**MINISTRY OF RECONSTRUCTION & HOUSING
STATE CORPORATION OF ROADS & BRIDGES
DEPARTMENT OF DESING &PLANNING**

Agenda of meeting: Samawah promenade project- design of Cornish Street

Subject: Minutes of Meetings in Samawah, Sat. 4-6-2005

資料 5 事業事前計画表

**Kornish Street
As Built Layout For The Existing Drainage System**

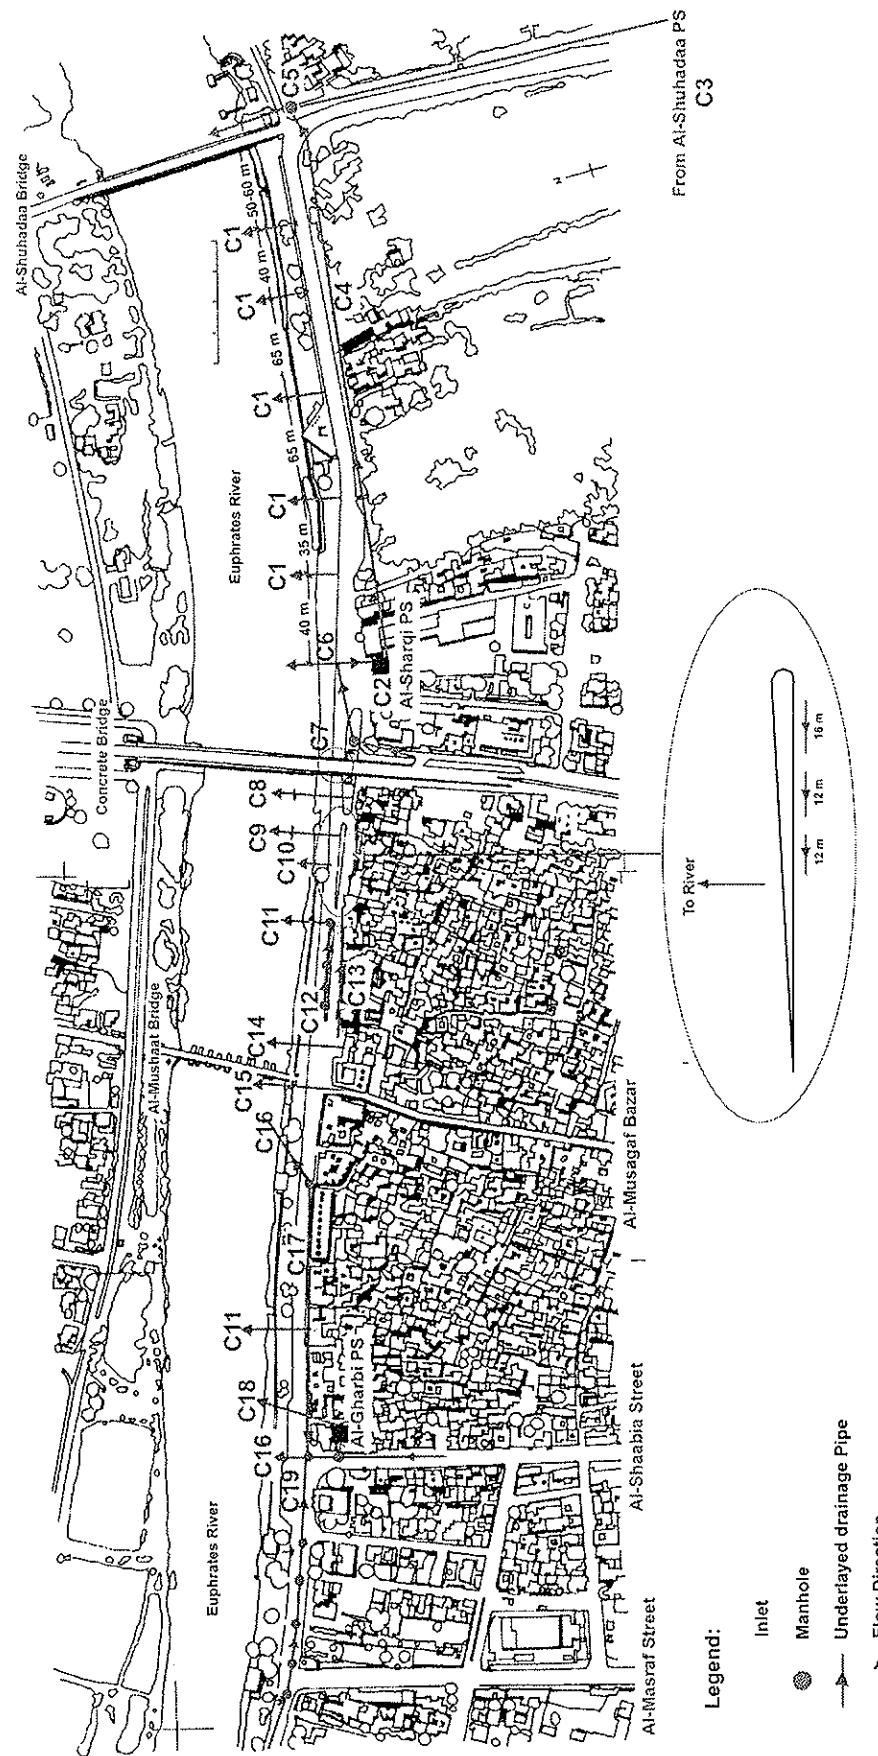
- C1. Side inlet connecting with \varnothing 200 PVC pipe that discharging to river.
- C2. Sewage Dept. comment:
There are several interruptions in electricity current in the remarked pumping station there fore in electrical Generator should be provided this station of size 150 KVA, otherwise an overflow pipe remarked in frontage of this station will re-generate odor over all the area.

- C17. \varnothing 500 concrete pipe. At each 25M there is a MH and an inlet connected with each other, also the drain pipes of the adjacent buildings are connected to these MHS.

- C18. \varnothing 200 steel and then PVC pumping pipe from Al-Garbi PS discharging to the river.
- C19. \varnothing 500 concrete pipe. At each 25m there is a MH at a distance of about (5m-8m) from river sides curb stone and in front of it there is a side inlet.
